CALIFORNIA REGIONAL WATER QUALITY CONTROL BOARD SAN FRANCISCO BAY REGION

RESPONSE TO WRITTEN COMMENTS FOR ITEM 6

On the Adoption of Site Cleanup Requirements for Guadalupe Rubbish Disposal Co., Inc., Guadalupe Mine, San Jose, Santa Clara County

1883. Photo 1 from Archeological Survey

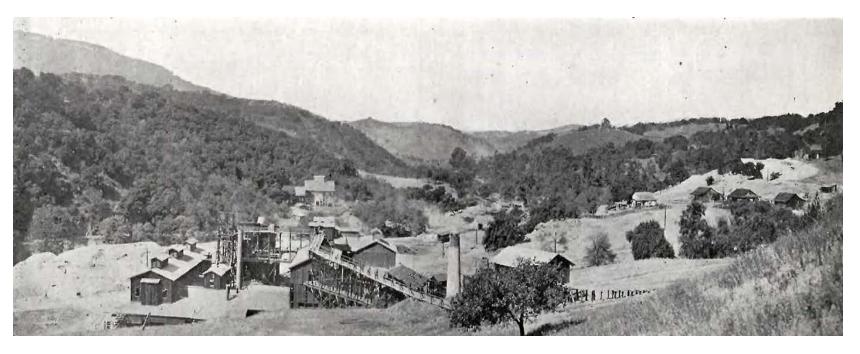
GRDC expands upon previous comments and asserts that cleanup requirements under section 13304 authorities are unnecessary and counterproductive given GRDC's history of cooperation and comparatively small contribution to mercury contamination in the watershed from erosion of Guadalupe Mine, especially considering that GRDC already implemented erosion control BMPs.

Staff disagrees that the tentative order is unnecessary (please see response to Key Comment 1) and counterproductive (please see response to comment 3). Staff acknowledges that the Guadalupe Mine produced much less mercury than New Almaden, by about a factor of 10 (see Section 3.4, Principal New Almaden Mines, in the TMDL Staff Report). However, to add perspective, only four other mines in the world have ever extracted more mercury than New Almaden. Thus, the amounts of mercury from the Guadalupe Mine remain significant. At the Guadalupe Mine, calcines were piled along the banks of Guadalupe Creek. Much of this waste is still evident, as can be seen in the following historic photographs.
